UNITED STATES PATENT AND TRADEMARK OFFICE

10/766,829

Office Action Summary

DETAILED ACTION

FIG. 1

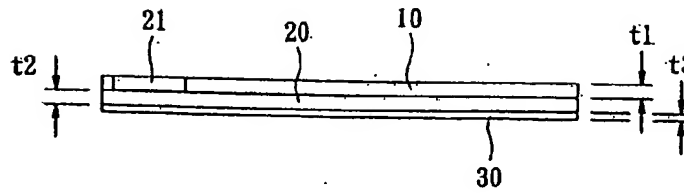
2. Figure 1 should be designated by a legend such as --Prior Art-- because only that which is old is illustrated. See MPEP § 608.02(g). Corrected drawings in compliance with 37 CFR 1.121(d) are required in reply to the Office action to avoid abandonment of the application. The replacement sheet(s) should be labeled "Replacement Sheet" in the page header (as per 37 CFR 1.84(c)) so as not to obstruct any portion of the drawing figures. If the changes are not accepted by the examiner, the applicant will be notified and informed of any required corrective action in the next Office action. The objection to the drawings will not be held in abeyance.

Drawings not acceptable. for 4/9/05
